## Planning Commission

**Planning Commission Meeting Agenda  
Hartland Township Hall  
Thursday, January 26, 2023  
7:00 PM**

HARTLAND TOWNSHIP PLANNING COMMISSION **DRAFT** MEETING MINUTES

**Subject:** Site Plan #23-001 M-59 Properties Planned Development (PD) Concept Plan

SHEET NUMBER  
L100

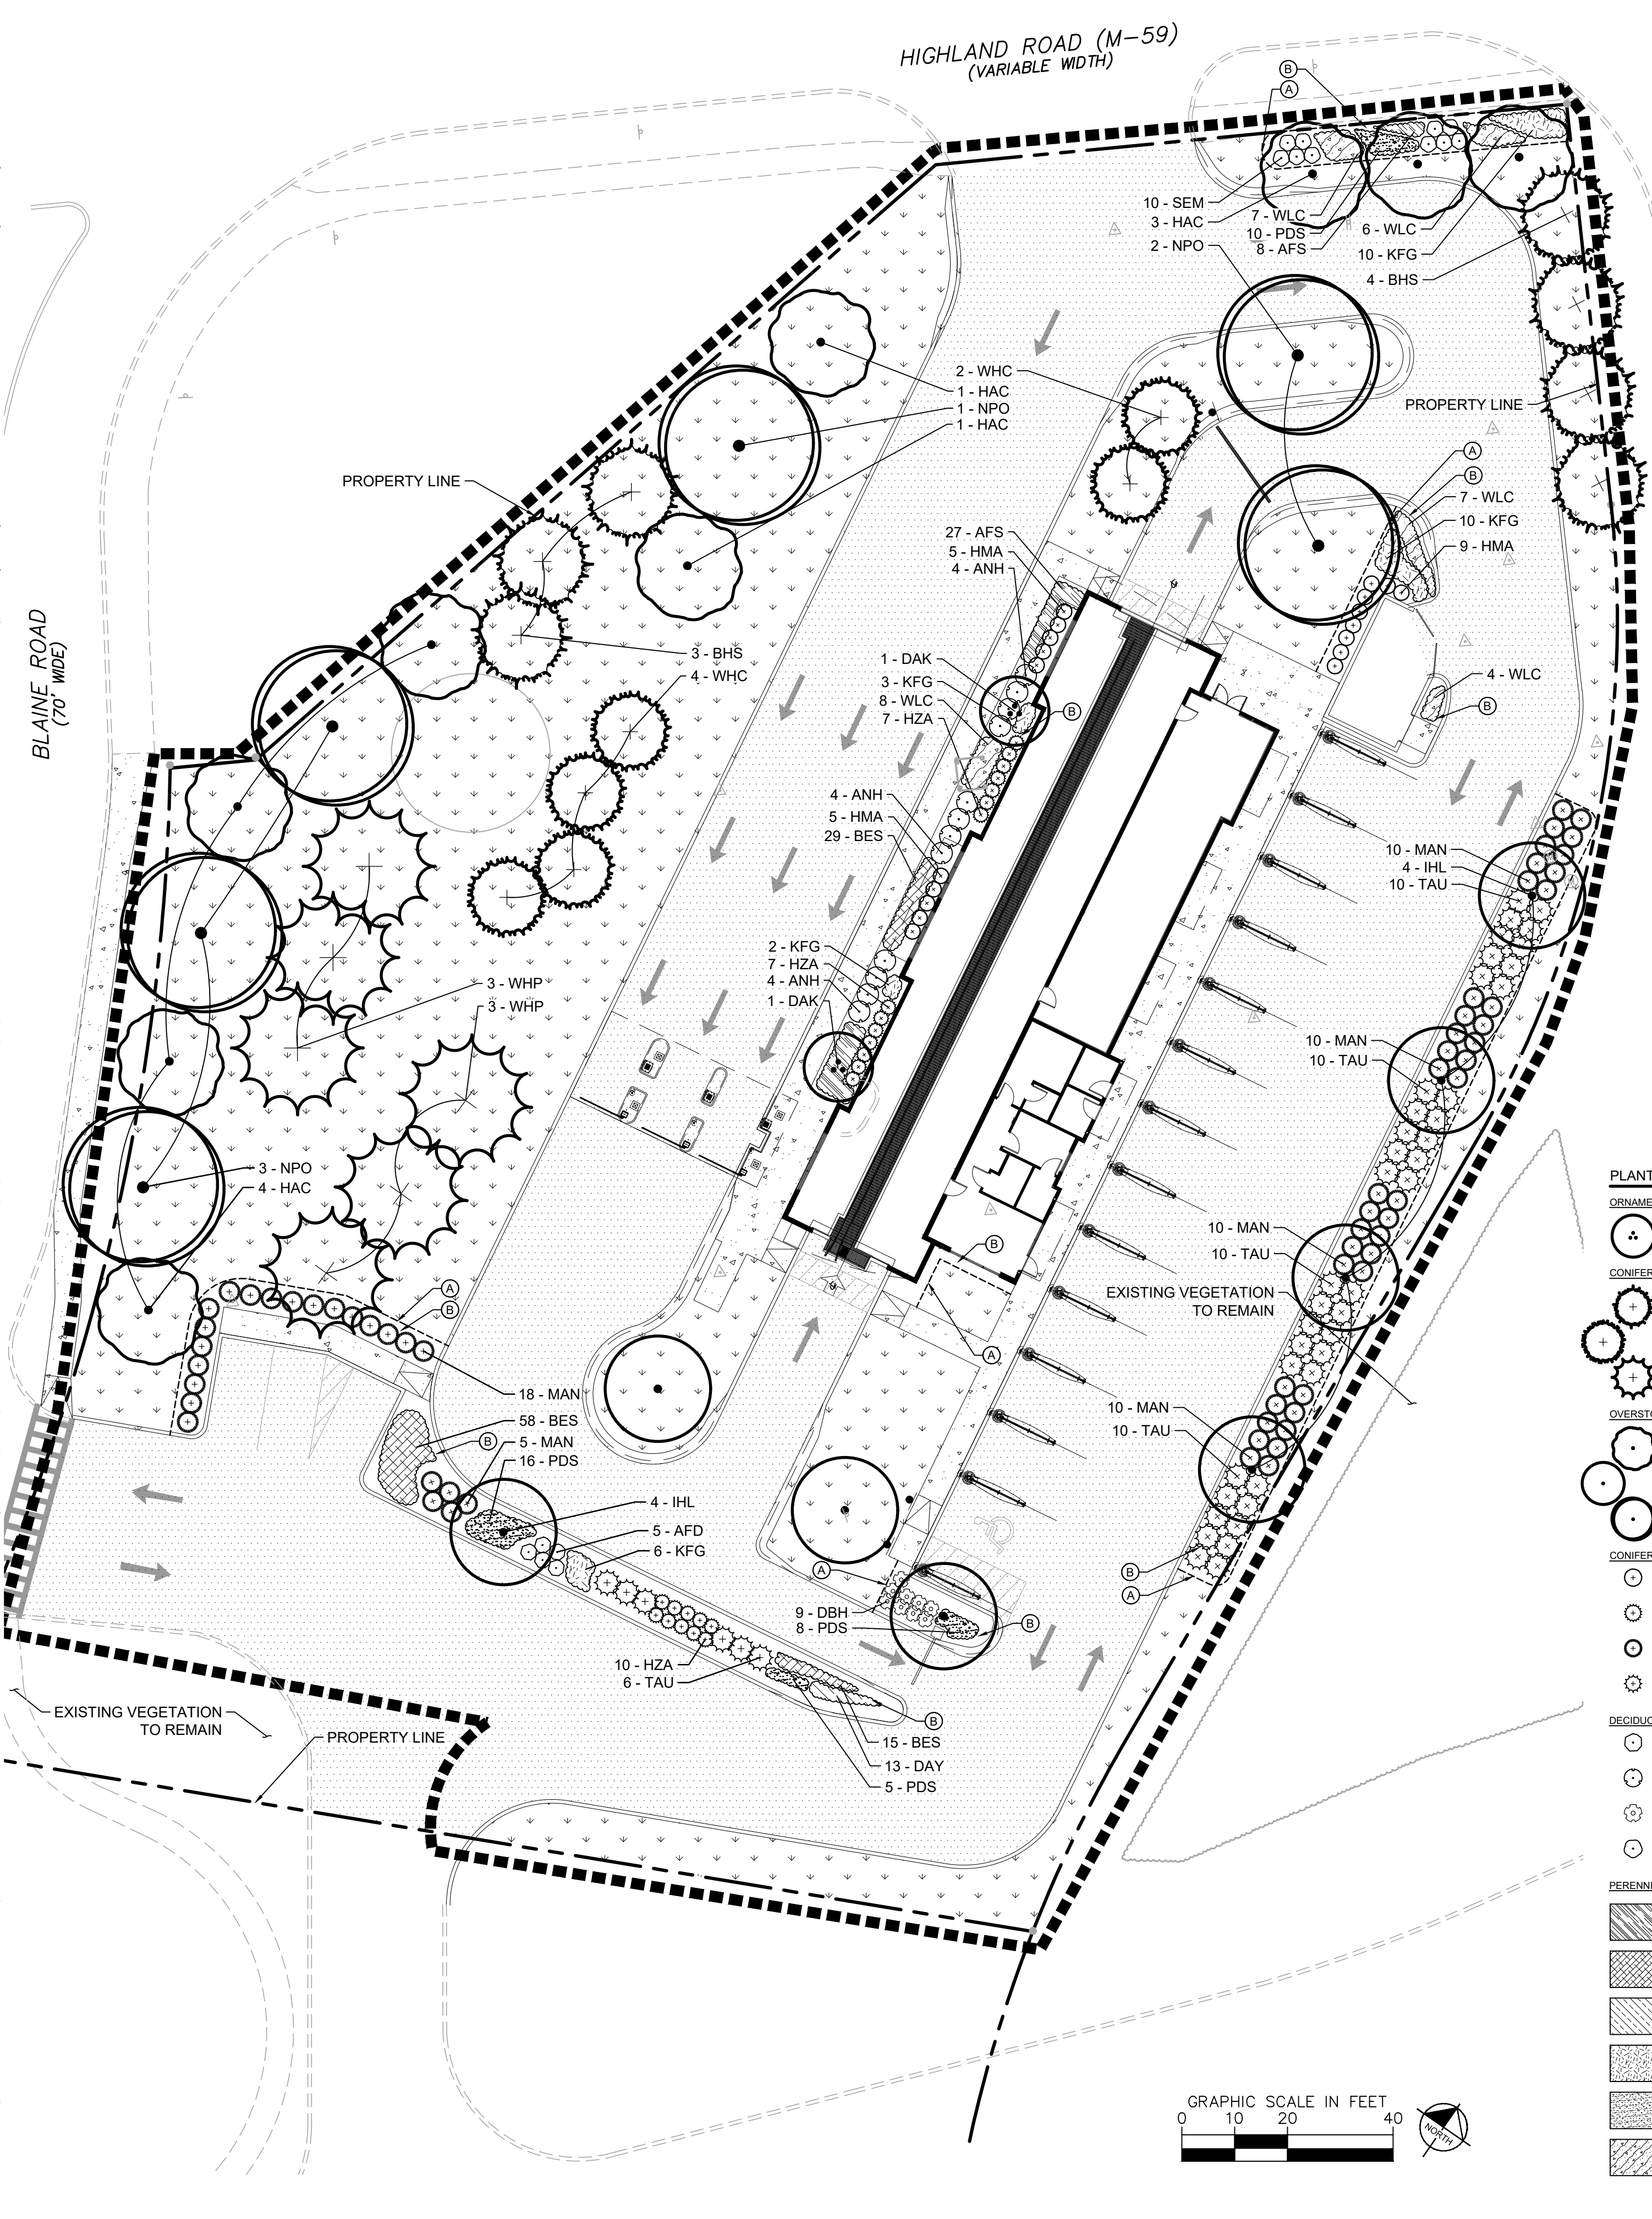
- Revised landscape plan with changes due to the reorientation of the building and parking. Additional landscape screening is provided on the west side of the site.
